# RAINAGE INFORMATION SHEET

RE: DRAINAGE REPORT OF CIELO GRANDE & CIELO VISTA SUBDIVISIONS  
RECEIVED JULY 30, 1986 FOR PRELIMINARY PLAT APPROVAL  
(H-10/D4)

DRAINAGE REPORT FOR  
CIELO GRANDE AND CIELO VISTA  
SUBDIVISIONS

**TITLE:** CIELO GRANDE SUBDIVISION  
OVERALL GRADING, DRAINAGE & PAVING PLAN 30 1986

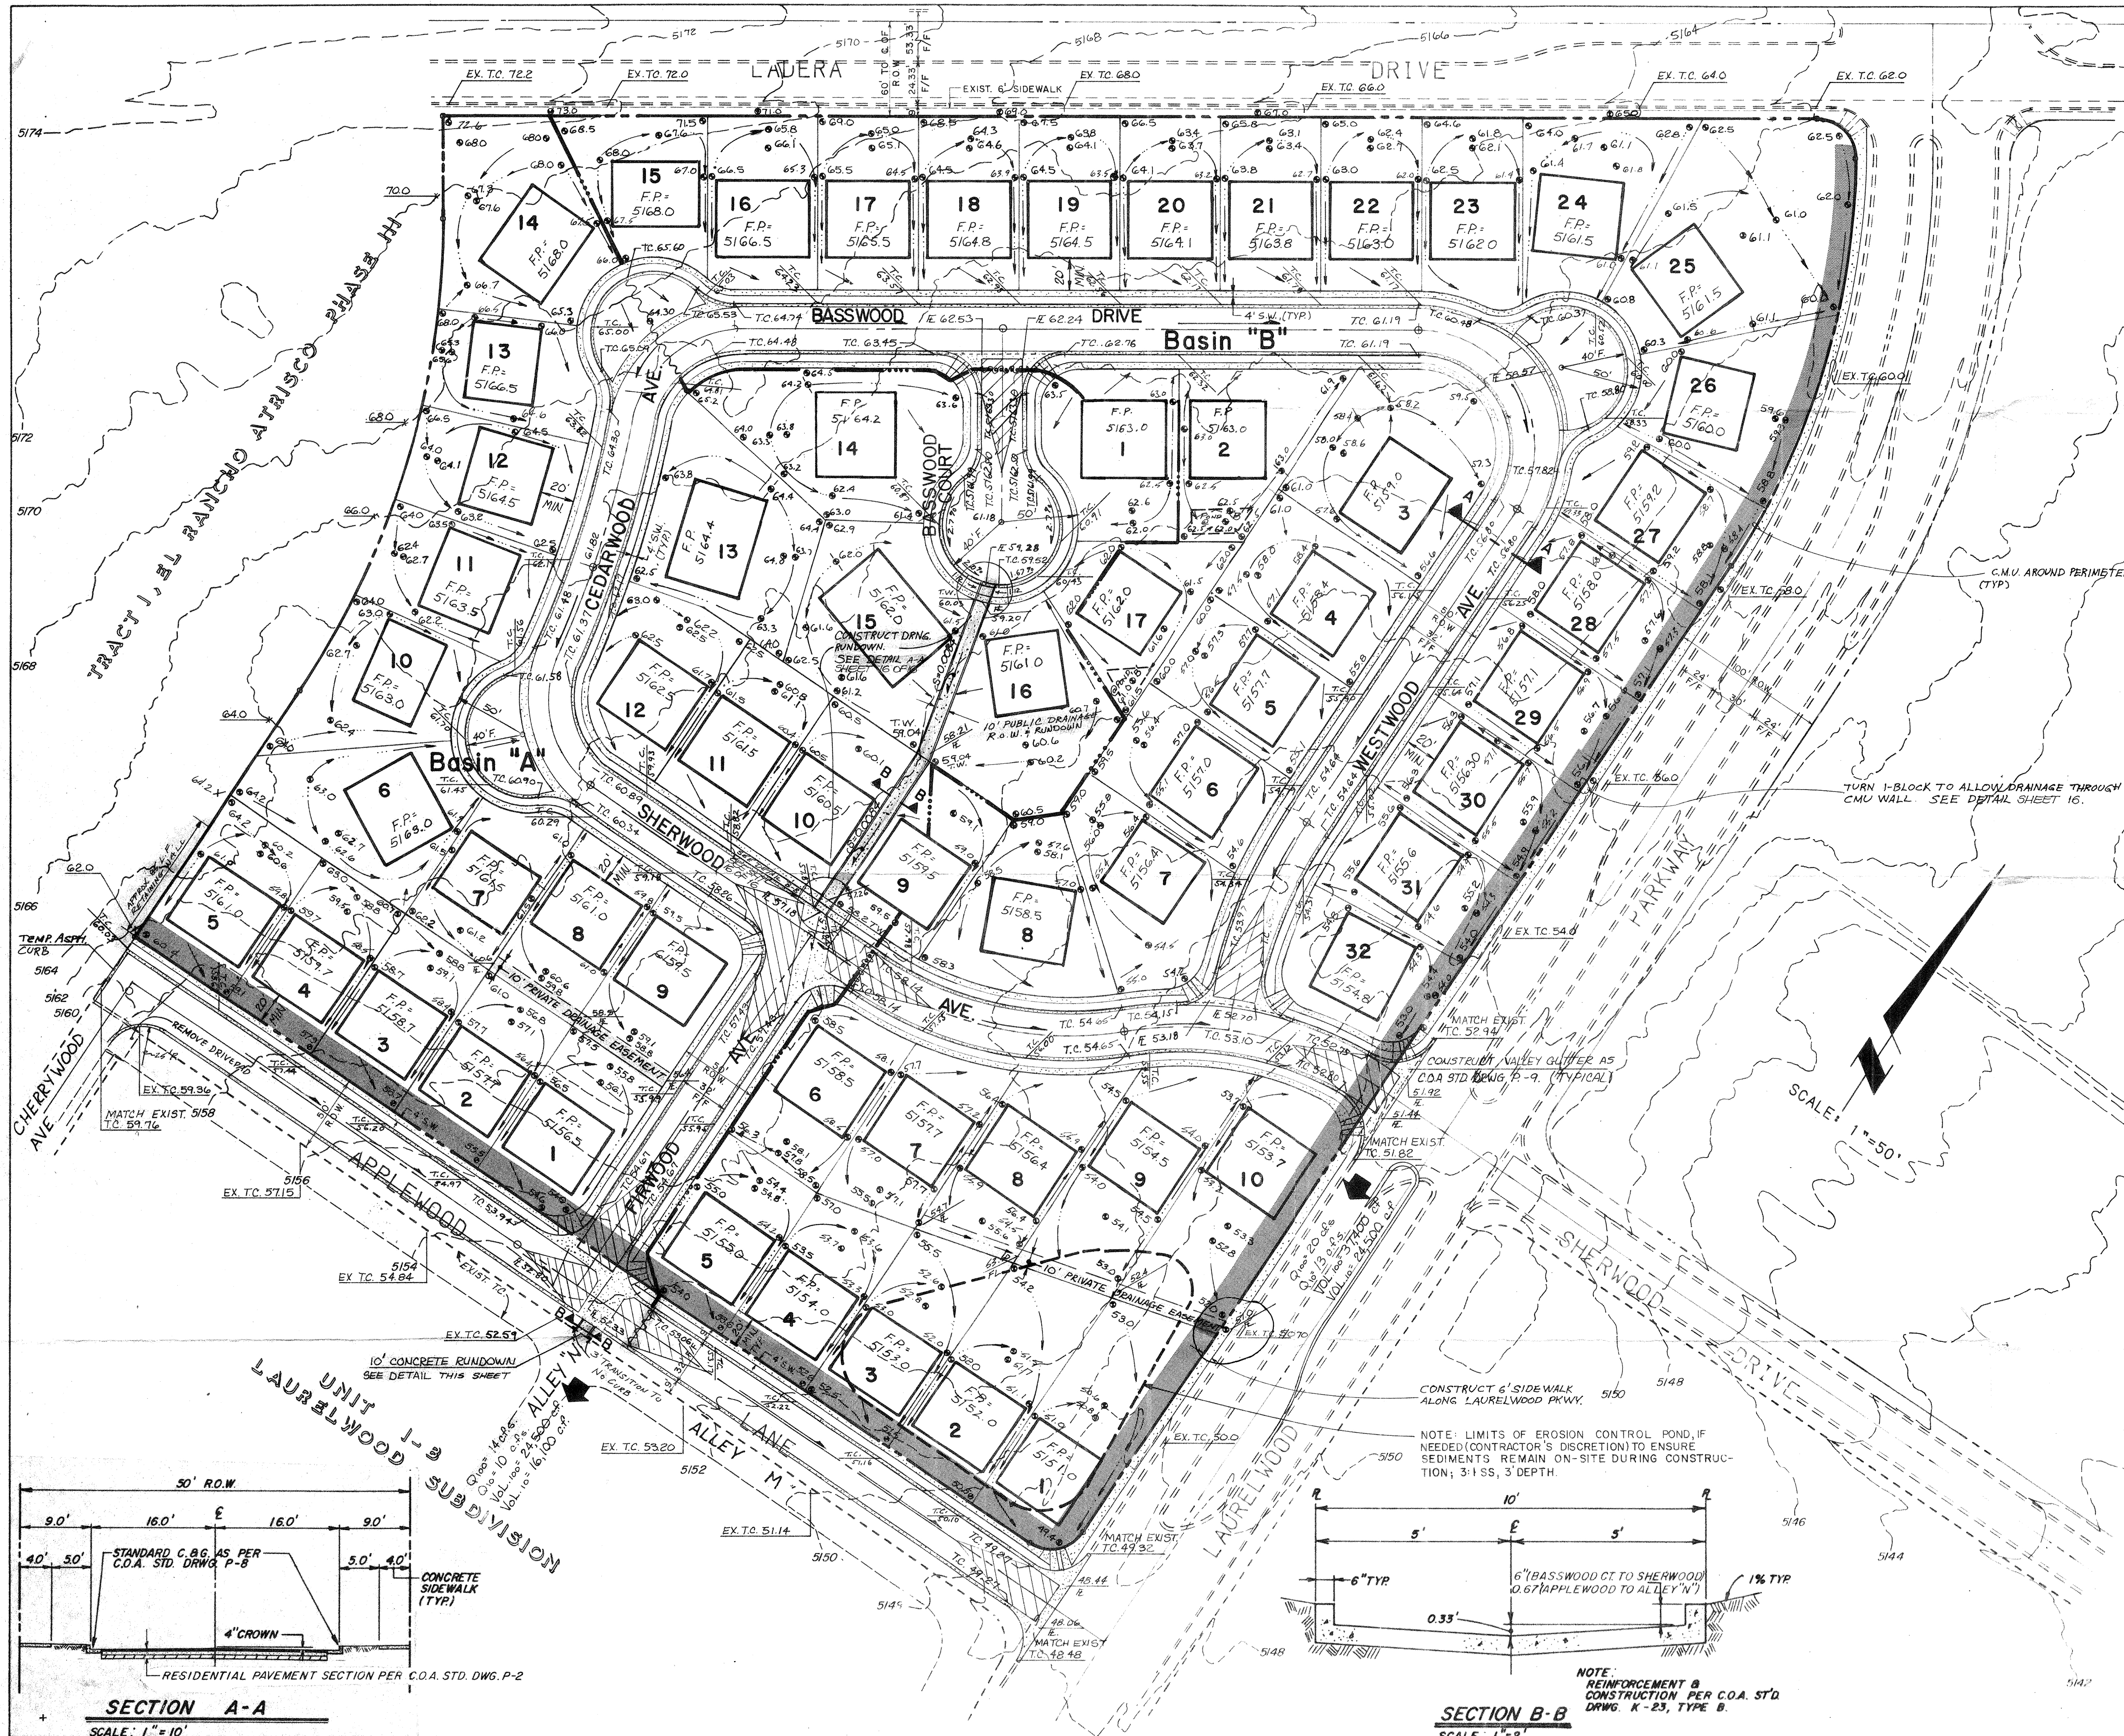
Prior to Final Plat sign-off by the City Engineer, the following items are required:

1. An executed Subdivision Improvements Agreement.
2. A Drainage Covenant covering maintenance responsibilities for the retention pond required for Cielo Vista Subdivision.

Both subdivisions are approved for Rough Grading provided the following information is added to the final Grading Plans to be included with the construction sets:

1. Identify a T.B.M. adjacent to project sites.
2. Add construction note that a Topsoil Disturbance permit is required.

3. Add construction note that a separate retaining wall permit is required from the Code Administration Division for private retaining wall construction.
